APPENDIX E. Stage 1 Road Safety Audit – Redlands Lane

Stage 1 Road Safety Audit

Redlands Lane, Emsworth

Proposed Walking and Cycling Improvements to Redlands Lane

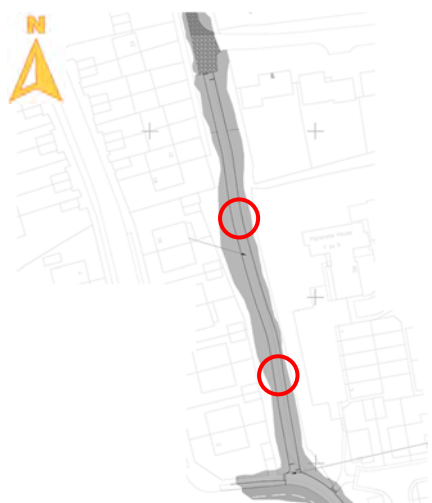
4.1	LOCAL ALIGNMENT
	No road safety concerns raised at this stage.
4.2	GENERAL
4.2.1	Problem
Location:	Redlands Lane junctions with Birch Tree Drive
Summary:	Existing lighting columns and road name plates are situated within the proposed shared footway / cycleway
The scheme includes the provision of a minimum 3 metre wide shared footway / cycleway on the eastern side of Redlands Lane, between its junctions with Birch Tree Drive. In order to accommodate the widening associated with the proposed shared footway / cycleway, the existing verge is to be utilised, where existing lighting columns and road name plates are present. In order to negotiate along the shared footway / cycleway in these locations, wheelchair / pushchair users may be required to enter into the carriageway where full height kerbs are present, to negotiate around the lighting column and/or road name plates, potentially resulting in vehicle to pedestrian collisions or fall.

Recommendation:	
It is recommended that the existing lighting columns and road name plates are relocated accordingly.	
Location Plan:

Accepted – At the detailed design stage existing lighting columns and road name plates will be relocated accordingly.

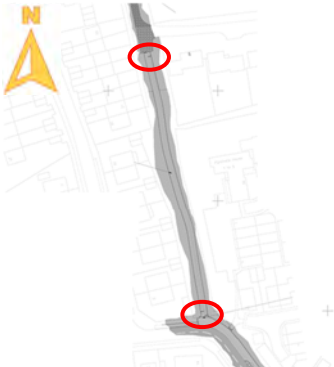
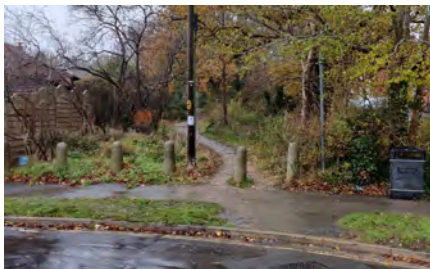
Various utility covers are present within the existing unmade track along Redlands Lane, along the route where it is proposed to provide the traffic free section of the 3 metre wide shared footway / cycleway. The utility covers appear to be set at a level above the top of the existing track. The Audit Team have concerns that the covers will protrude above the level of the proposed footway / cycleway, which will be a trip hazard leading to personal injuries.

It is recommended that all cover levels are adjusted appropriately.

Accepted - At the detailed design stage all cover levels will be adjusted appropriately.

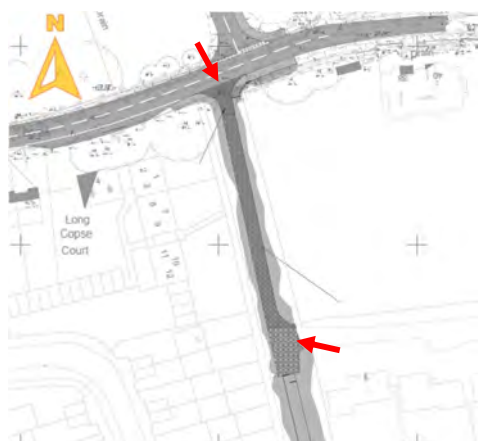
4.4.2	Problem
Location:	Redlands Lane
Summary:	Lack of advance warning of the potential for pedestrians to be present in the carriageway
The scheme drawing provided with the Audit Brief indicates that the northern section of Redlands Lane is to continue to operate as a shared carriageway between vehicles and pedestrians / cyclists. At this stage, the Audit Brief does not include details of the

proposed signage. A lack of advance warning for vehicles approaching the shared surface could result in drivers not being made aware pedestrians could be present in the carriageway. This could lead to heavy braking and rear impact collisions, loss of control type collisions or vehicle to pedestrian collisions.

It is recommended that advance warning is provided on the approaches to the shared surface to inform drivers of the potential for pedestrians to be present in the carriageway.

Accepted - At the detailed design stage advanced warning signs will be provided on approach to the shared surface section in order inform drivers of the potential for pedestrians. A note has been added to drawing ITB13525-GA-103 Rev C.

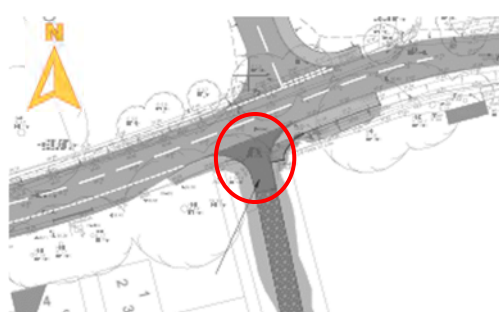
The scheme drawing provided with the Audit Brief indicates that the northern section of Redlands Lane is to continue to operate as a shared carriageway between vehicles and pedestrians / cyclists, however, it is unclear if any on-carriageway change in surface materials are to be provided at the junction to inform drivers of the change in carriageway to a shared surface. A lack of a suitable on-carriageway warning for drivers entering the shared surface could result in drivers being unaware that pedestrians may be present in the carriageway ahead. This could lead to inappropriate vehicular speeds and vehicle to pedestrian collisions.

It is recommended suitable measures are provided to highlight the change in nature of the carriageway to a shared surface.

Accepted - At the detailed design stage suitable measures will be provided to highlight the change in nature of the carriageway to a shared surface. A note has been added to drawing ITB13525-GA-103 Rev C which is supplemented by a surface change provided at the point Redlands Lane meets Long Copse Lane – this shown on the updated drawing.

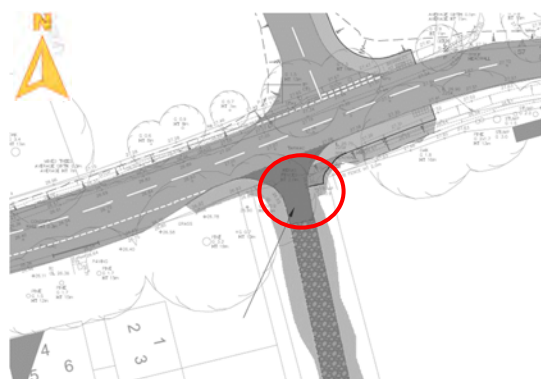
The scheme drawing provided with the Audit Brief indicates that the northern section of Redlands Lane is to continue to operate as a shared carriageway, with pedestrians and vehicles sharing the carriageway on an equitable basis. The proposed footway is shown to wrap around the corner radius and terminate on Redlands Lane. No level access between the proposed footway and shared surface carriageway is illustrated on the scheme drawing. Full height kerbs will be an obstruction for pedestrians and could lead to trips, falls and personal injury. Furthermore, it is unclear if suitable measures will be provided to ensure users will be informed of the change in route characteristics. Insufficient advance warning could lead to users, including the visually impaired, stepping into the carriageway and into the path of vehicles, resulting in vehicle to pedestrian / cycle collisions.

It is recommended that the edge of carriageway where users transition from the footway to the carriageway is not formed with kerbs in excess of 6mm and that suitable measures

are provided on approach to the shared carriageway to ensure that footway users are made aware of the change in route characteristics.

Accepted – A dropped kerb has been shown on drawing ITB13525-GA-103 Rev C and at the detailed design stage it will be ensured that the transition from the footway to the carriageway is not formed with kerbs in excess of 6mm. In addition, advanced warning signs will be provided on approach to the shared surface section in order to ensure that footway users are made aware of the change in route characteristics.

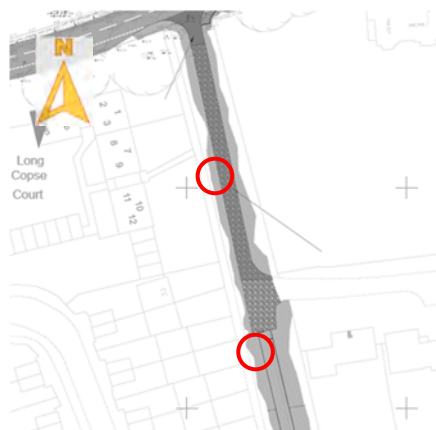
A number of lighting columns are present along the northern section of Redlands Lane. Existing vegetation was observed to obscure the illumination levels of the existing lighting columns. Whilst vehicles are driven during the hours of darkness with head lights illuminated, drivers may not become aware of the presence of pedestrians at a safe distance, which could give rise to vehicle to pedestrian / cyclist collisions. Furthermore, tree canopies and overgrown vegetation are present along Redlands Lane which would generate shadows, restricting clear visibility of pedestrians negotiating along Redlands Lane.

It is recommended that a suitable level of street lighting is provided and that vegetation is maintained clear of any lighting.

Accepted - At the detailed design stage a lighting strategy and design will be provided. A note has been added to drawing ITB13525-GA-103 Rev C.
